RE: Response to Comments, Bennoc Area NPDES OIL00159 Application for American Energy Corporation in Belmont County, Ohio

Response to OEPA Comments from Bruce Goff and Eric Nygaard Dated 8/21/12, 8/15/12, 7/20/12, 7/13/12, and 7/11/12 Bennoc NPDES Permit Application OIL00159

Hydro-Chemical Analysis of Waste Water Discharge and Anti-Degradation Assessment: American Energy Corporation's Bennoc Coarse Coal Refuse Area Ponds 001 and 002

Section A'-A

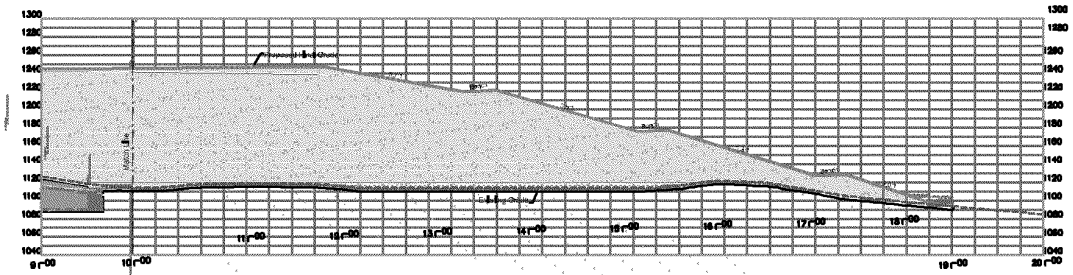
Comment: Also send us some typical cross sections of the refuse disposal area. Include a cross section before disposal of refuse, a cross section during disposal and a final cross section showing final grades and reclamation.

Response: Cross sections of the area for before disposal and after reclamation can be found in the attached drawing Sections A'-A & B'. During disposal cross-sections would be difficult to supply due to the constant change during construction.
